Delegated Report	Analysis sheet N/A		Expiry Date:	12/07/2021			
			Consultation Expiry Date:	12/07/2021			
Officer		Application N	lumber(s)				
Josh Lawlor		2021/2444/P					
Application Address		Drawing Num	bers				
The Dutch House 307 - 308 High Holborn London WC1V 7LL		See Decision	Notice				
	m Signature C&UD	Authorised O	fficer Signature				
Proposal(s)							
Installation of 1 antenna on wall mounted pole to replace existing 1 x antenna, installation of 2 x antennas on tripod fixed to existing steel platform to replace existing 2 x antennas and addition of ancillary development including 1 x GPS module and ERS units.							
Recommendation(s):	Refuse Planning Permission						
Application Type:	Full Planning Permission

1.1. The application permission for one antenna to be removed and replaced with one no. new antenna on a new wall-mounted pole at a height of 31.10 metres. The proposed installation of two no. antennas to be removed and two no. new antennas are to be relocated and mounted on the proposed tripod fixed to the existing steel platform at 31.10 metres. The proposed addition of ancillary development, including one GPS module and one Emergency Response System unit. The

Proposed site plan showing mast located on roof edge circles in blue

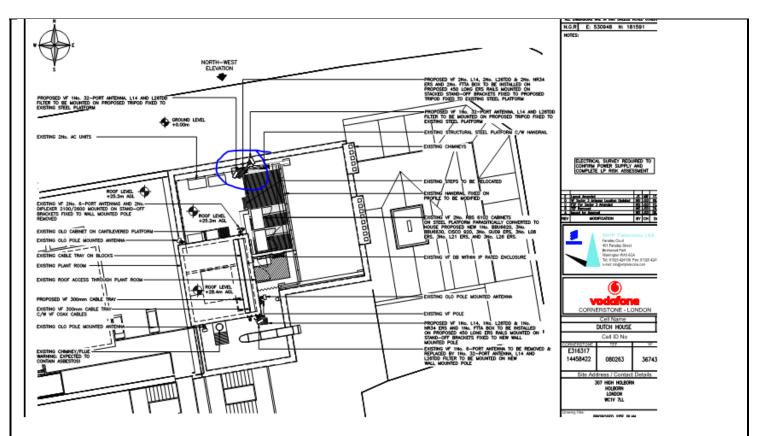
- 4.3. The wall mounted antenna/pole is acceptable in terms of location as it is set back from the roof edge. The installation of two antennas on tripod fixed to an existing steel platform on the edge of the roof facing High Holborn (north west), would be visible from street level. It is an incongruous feature, creating visual clutter that would harm the character and appearance of the host building. Although the building is not architecturally distinguished or noted as making a positive contribution to the character of the conservation area in the appraisal, the appearance of the roofline along High Holborn is an important aspect of this part conservation area. This proposal has not been sensitively designed to preserve this relatively consistent roofline as far as possible.

- 4.4. The proposed development harms the character and appearance of the Bloomsbury Conservation Area, from which the equipment would be visible along the key thoroughfare of High Holborn. It is noted that the approved applications Refs 2019/1466/P, 2023/0687/P, and 2020/1962/P (see planning history) did not include a mast located on the roof edge facing High Holborn.

- 4.5. Overall, considering the visual prominence of the development and the context of the site within the Bloomsbury conservation area, it is considered that the proposed poles with antennas, by reason of their inappropriate siting, scale and bulk, would represent incongruous and unsympathetic additions that would introduce unacceptable visual clutter at roof level which would harm the visual appearance and character of the street scene, and would fail to preserve or enhance the character and appearance of the host building or conservation area, contrary to policies D1 and D2 of the Camden Local Plan 2017, the London Plan and NPPF. The development causes less than substantial harm to the Bloomsbury Conservation Area. In accordance with paragraph 202 of the NPPF, the development brings minor public benefits through the provision of telecoms equipment; however, other less harmful telecoms development has been approved at the site, and as such, the limited public benefit would not outweigh this less than substantial harm.

1. The proposed pole mounted antennas located on the roof edge fronting High Holborn, by reason of its siting and design, would be detrimental to the appearance of the host building and character and appearance of the Bloomsbury Conservation Area, contrary to policy D1 (Design) and D2 (Heritage) of the Camden Local Plan 2017 and the National Planning Policy Framework 2021.
